Memorandum

TO: District of Columbia Zoning Commission

FROM:  Jennifer Steingasser, Deputy Director Development Review & Historic Preservation

SUBJECT: **ZC 06-04 C- Modification** – 1600 North Capitol Street, N.W.

North Capitol Street Elevation (06-04) (2007)

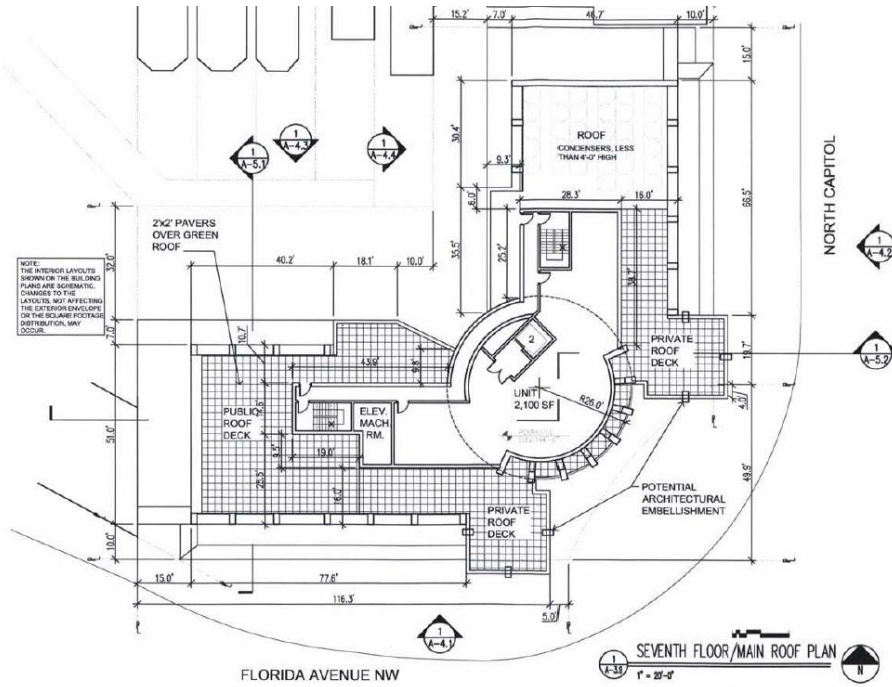
The immediately visible changes to the building’s design include changes to the upper level roof plan and a decreased gradient for the site; with a lower lobby entrance than previously designed (*see A 6.1 for street perspective*)
